## HISTORIC AND DESIGN REVIEW COMMISSION

**HDRC CASE NO:** 2017-077  
**ADDRESS:** 114 E HOUSTON ST  
**LEGAL DESCRIPTION:** NCB 133 ALL OF BLK  
**ZONING:** D, HS, RIO-3  
**CITY COUNCIL DIST.:** 1  
**DISTRICT:** Main/Military Plaza Historic District  
**APPLICANT:** Patrick Winn, AIA/Total Art Design & Architecture  
**OWNER:** Weston Urban  
**TYPE OF WORK:** Installation of concrete stoop and steps  
**REQUEST:**

The applicant is requesting a Certificate of Appropriateness for approval to construct a concrete stoop and steps on the Soledad facade of the structure at 114 E Houston and in the public right of way.

# 08 ENTRY 103 ELEVATION

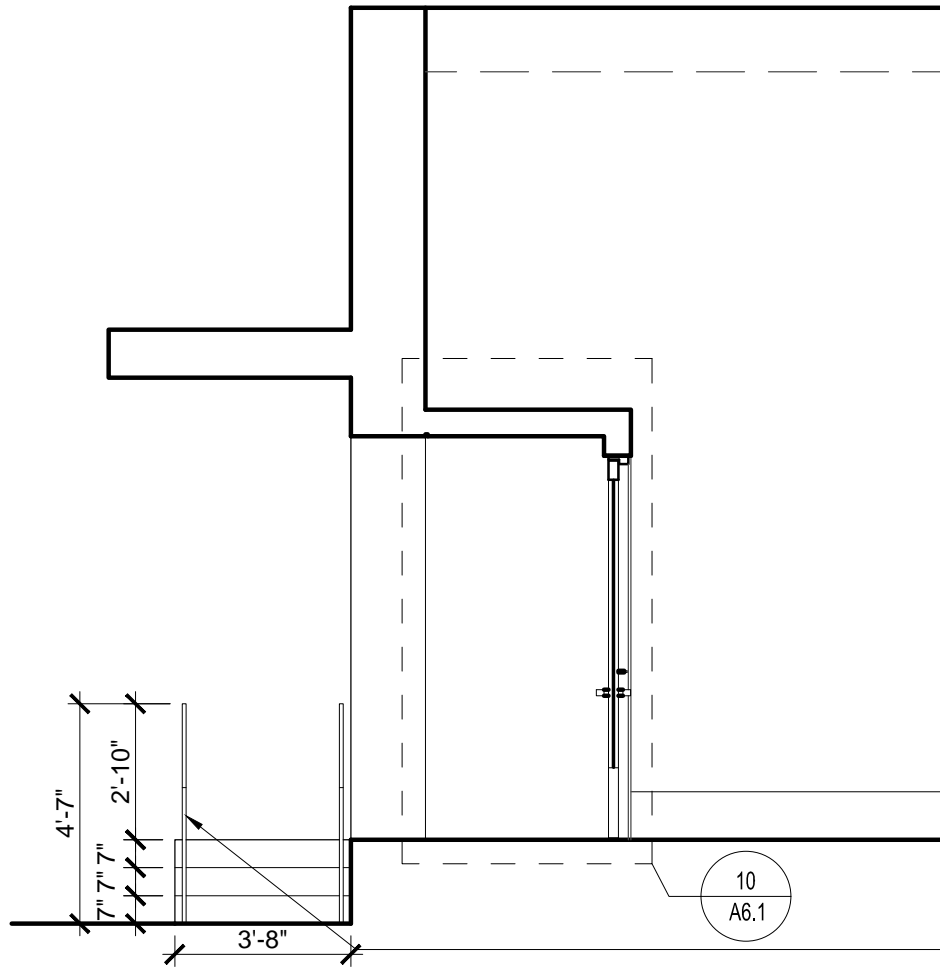
- c. The applicant has proposed a handrail, but has noted that final handrail specifications have not been finalized. Staff finds that a square or a small circular hand rail would be appropriate. The applicant is to present the final handrail design to staff prior to installation.

Staff recommends approval based on findings a and b with the stipulation that the applicant provide staff with the final handrail design for review prior to installation.
